In the matter of an application by Gore District Council for resource consent to
establish the Longford Bridge across the Mataura River

Statement of evidence of Daniel Anthony Crocker

2 December 2020

Figure 1 (above) – Long-section showing indicative changes (drawn to scale) caused by lifting bridge by 500mm.

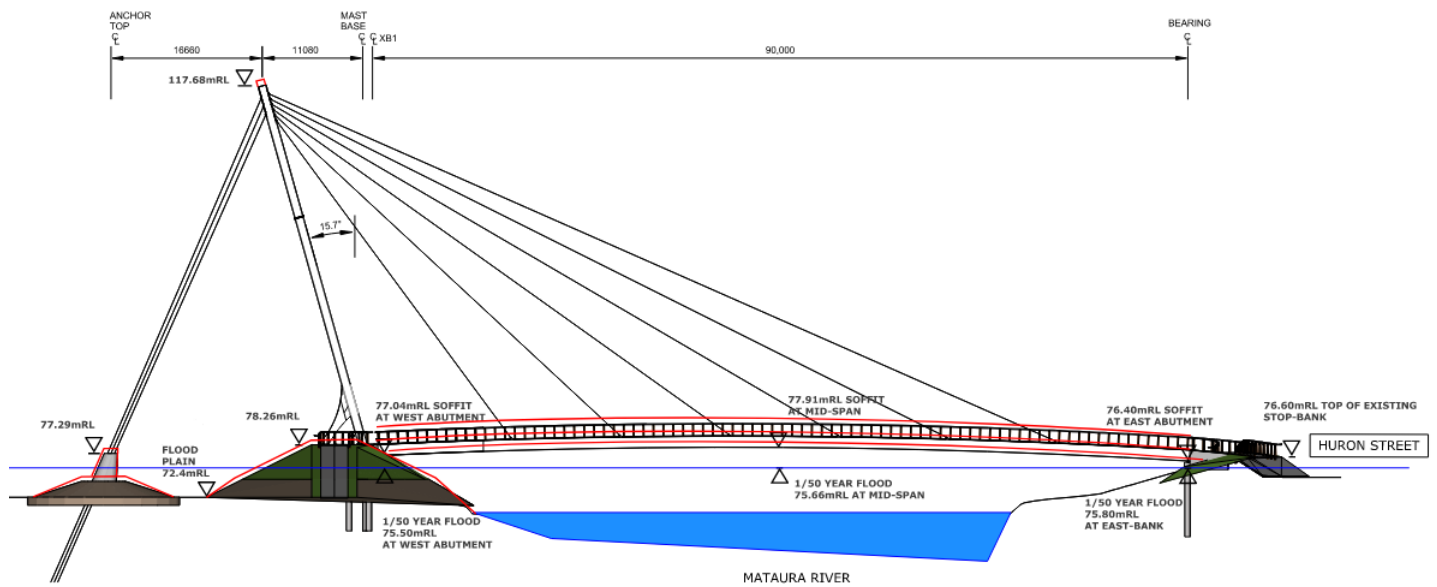
43 In summary, the main outcome of increasing stop-bank levels is to increase the amount of debris forces that the bridge will need to accommodate. Two options are available to mitigate this outcome:

Option 1: The bridge is lifted 500mm everywhere

44 This will include increasing the western embankment by 500mm, increasing pile lengths by 500mm, and increasing the height of the dead-man anchors by 500mm. It is also expected that the foundations of the dead-man anchor surrounds will need to increase to resist the increased overturning demands. These changes are indicated in the figure below. At this stage rather than increasing the overall footprint of the embankment and anchor surround we would steepen the side batter of the "zone 1" rip rap extents (zone 1 is indicated on drawing S106) from 1V:2H to 1V:1.5H. This approach will need to be confirmed by detailed geotechnical stability analysis.

45 At this stage, I would estimate that a 500mm increase in both the western embankment and dead-man surround would increase quantities as follows:

- (a) west embankment fill = +480m³;
- (b) west embankment rip rap = +260m³;
- (c) anchor fill = +105m³;
- (d) anchor Rip Rap = +105m³; and
- (e) eastern stop-bank tie-in fill = +20m³.
- (f) Bridge Piling = +3.5m.

Figure 2 (above) – Plan showing steelwork elements likely to require strengthening when increased debris loads are applied (TBC by detailed analysis).

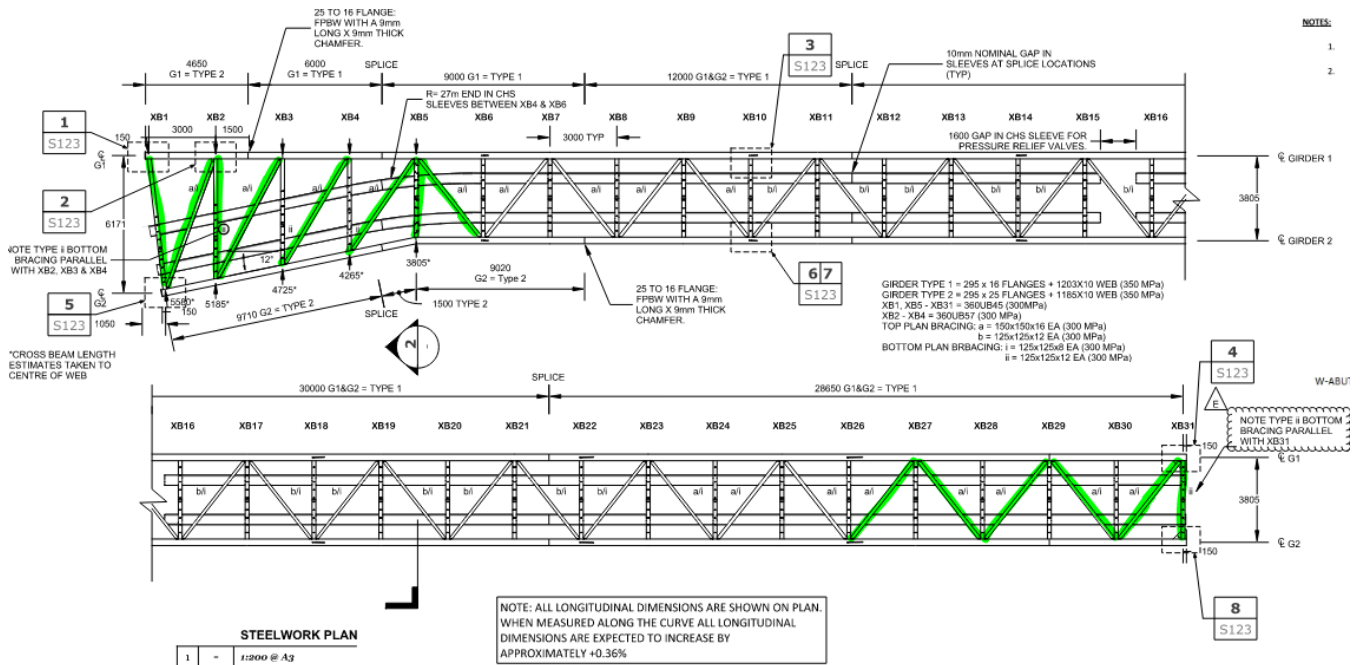
Option 2: The bridge is strengthened

46 It might be possible to leave the bridge geometry and alignment "as is" if the bridge were strengthened to resist higher flood debris loads. At this stage, I would expect an incremental section size increase of the structural bracing members, bracing connections, the hold-down bolts, and bridge piles. These anticipated strengthening requirements are highlighted in the figure below. I do not expect this to change the overall geometry of the bridge.
